Response-to-Comment to Sewerage Impact Assessment Report

Section 12A Rezoning Application for Proposed Columbarium on Various Lots in D.D.41, Sha Tau Kok, New Territories

Sewerage Impact Assessment Report

Reference: P036/03 Issue 3

Figure 3.1

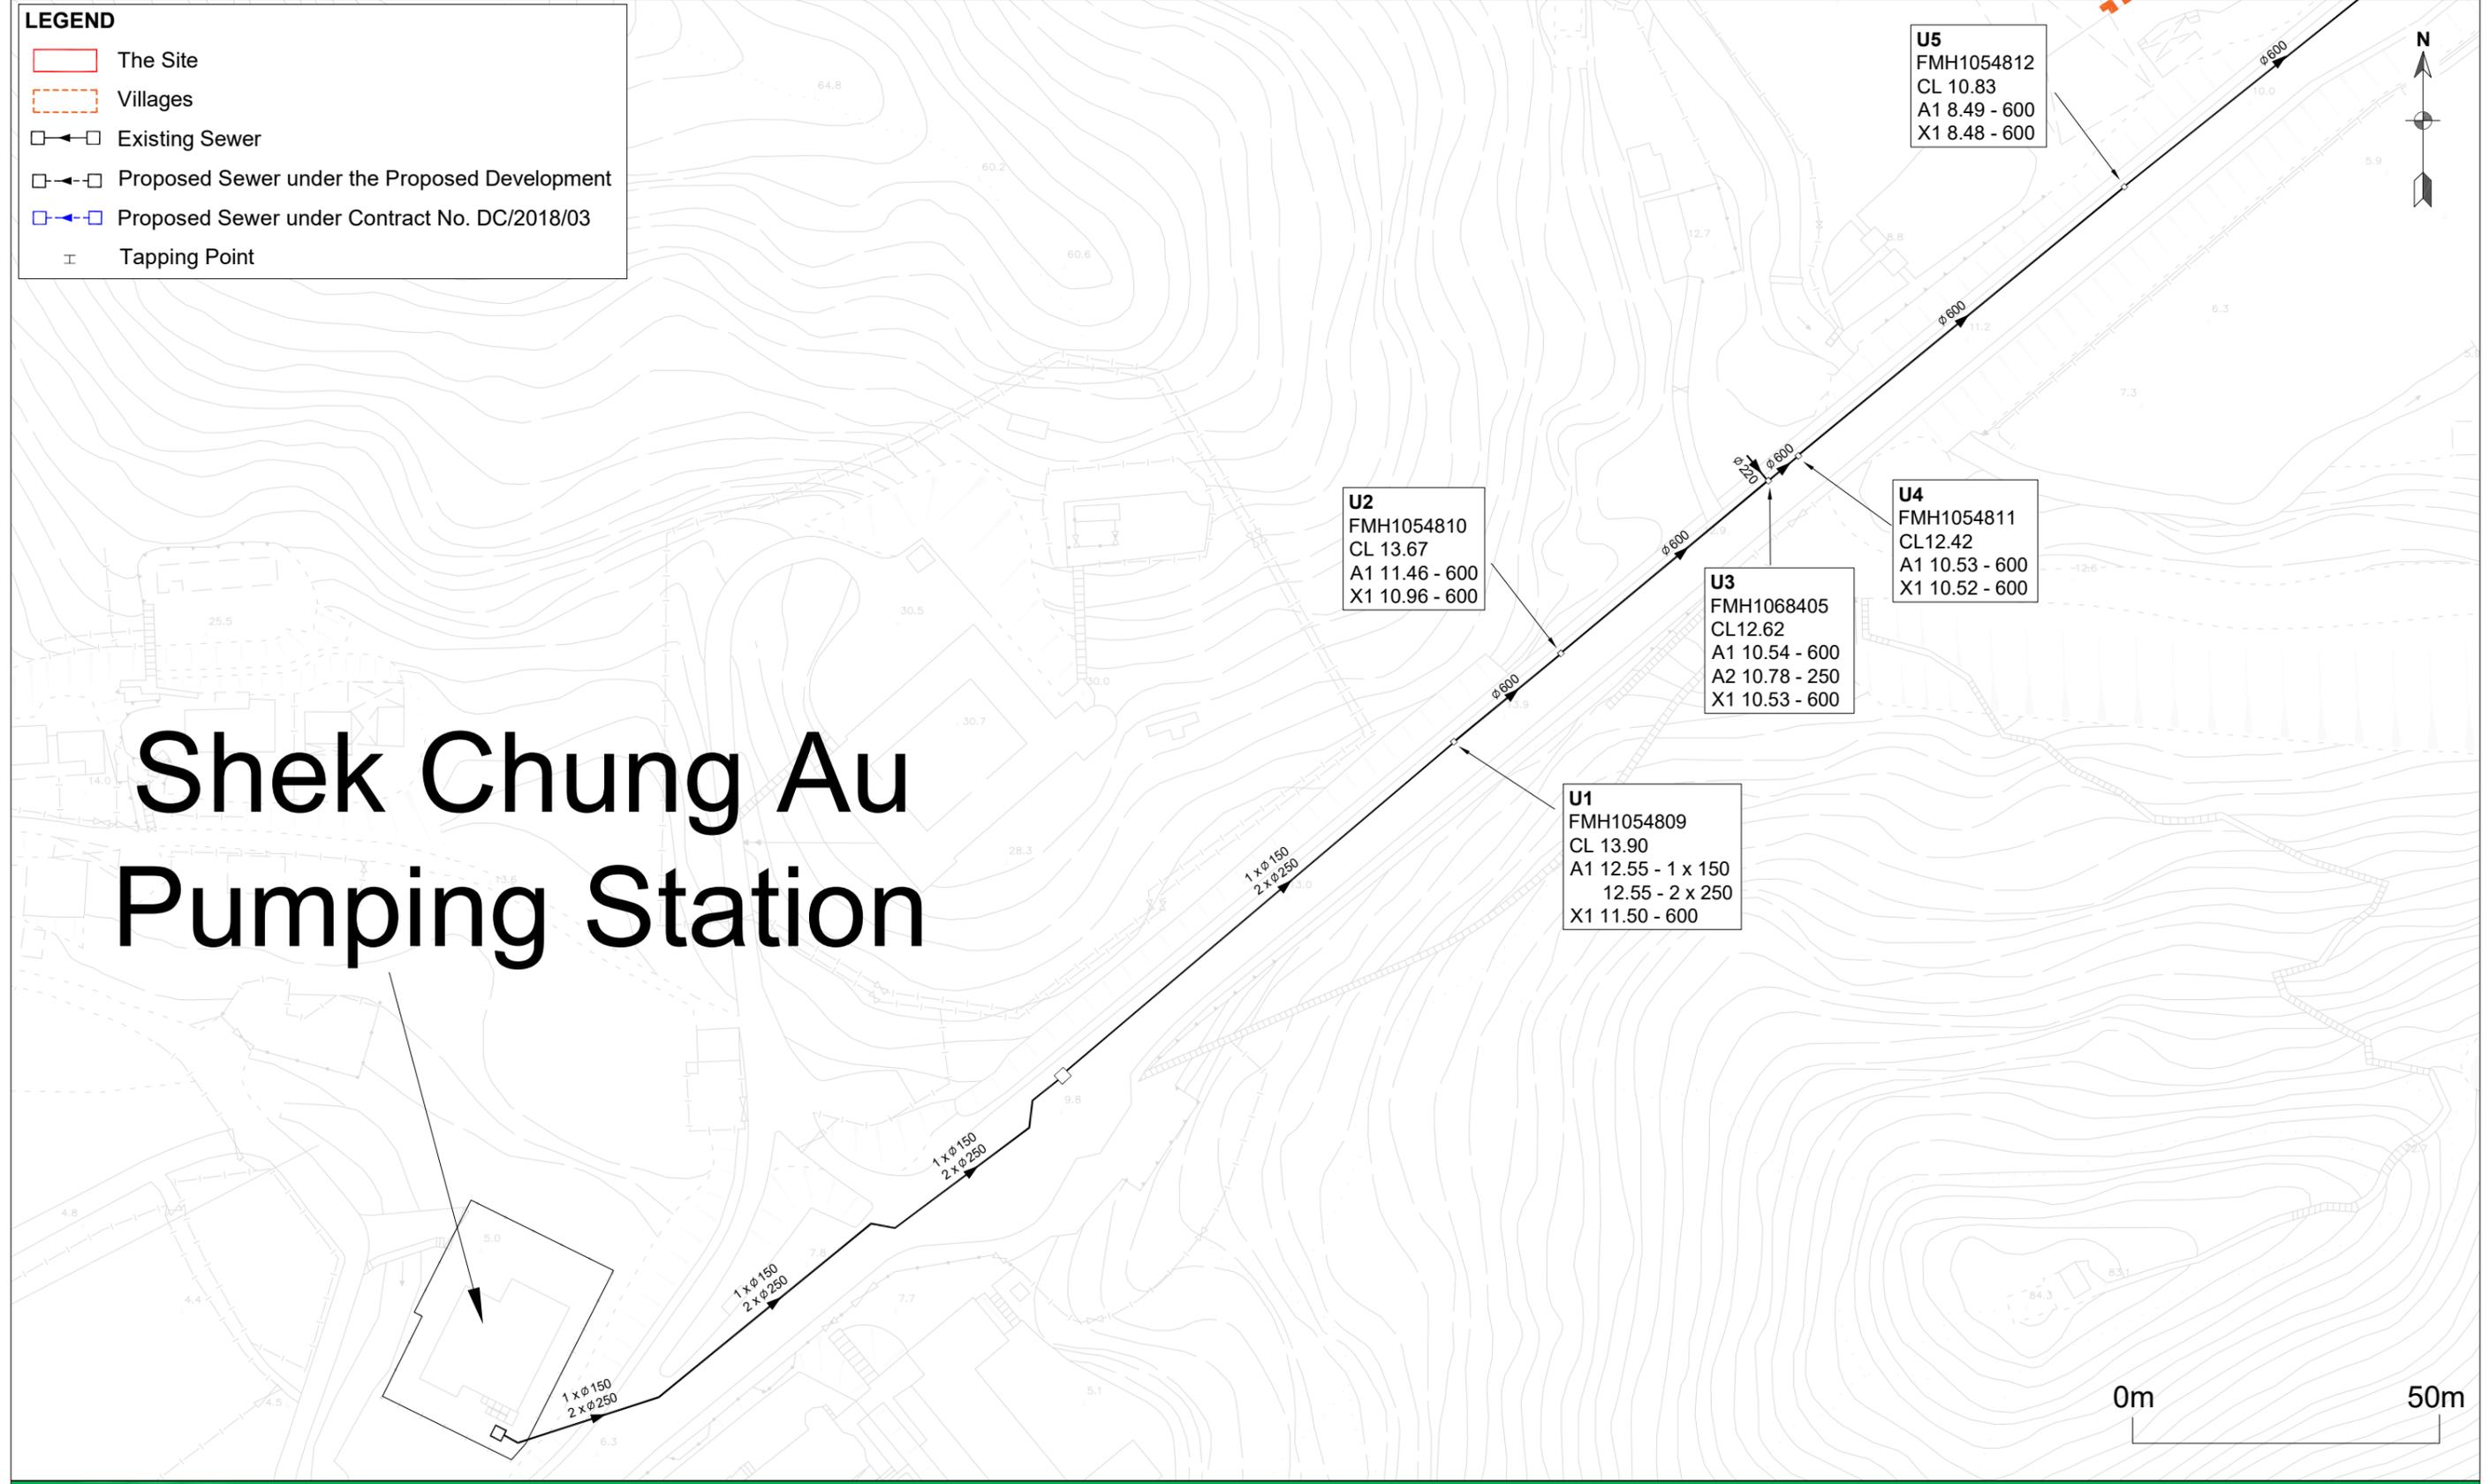
Items	Comments	Response
Comments on Sewerage Impact Assessment from DSD		
a	This SIA report needs to meet the satisfaction of EPD, the planning authority of sewerage infrastructure.	Noted.
b	The applicant should check and ensure that the existing sewerage system to which the proposed connection will be made have adequate capacity and satisfactory condition to cater for the additional discharge from the site. He should also ensure that the flow from this site will not overload the existing sewerage system.	Noted.
c	Figure 3.1 should show the alignment of all existing public sewerage network in the vicinity of the site. The applicant should ensure that a 3m clear distance between the proposed structure and the existing public sewerage network would be maintained.	Noted. Figure 3.1 shows the alignment of existing public sewerage networks along Sha Tau Kok – Shek Chung Au. It is confirmed that a distance of more than 3m between the proposed structure and the existing public sewerage network is maintained. Please refer to Figure 3.1.

d	Consideration should be given to adopt polyethylene (PE100) pipe for buried sewage pipe beyond the sewage terminal manhole.	Noted. Polyethylene (PE100) pipe will be adopted.
e	The location of the terminal manhole shall be designed and constructed close to the lot boundary as far as practicable.	Noted and revised. The location of the terminal manhole has been designed to be as close to the lot boundary as possible. Please refer to Figure 3.1.

Comments on Sewerage Impact Assessment from DSD		
1	Figure 3.1 has not shown the alignment of all existing public sewerage network in the vicinity of the site (e.g. the sewerage system at Tong To). The applicant should review.	Noted and updated. Please refer to Figure 3.1.
2	RtoC item h: Please update section 5 regarding the handover arrangement of sewerage pipe to DSD. Please note that DSD would only consider taking up the maintenance of connection pipe located downstream of the terminal manhole and outside the private lot boundaries after satisfactory technical audit by DSD. The applicant should be responsible for the maintenance of pipes constructed under this development which have not been handed-over to other parties for maintenance.	Noted and revised. Please refer to Section 5.
3	Unless the applicant can submit satisfactory DIA and SIA reports, I do not support the application.	Noted.
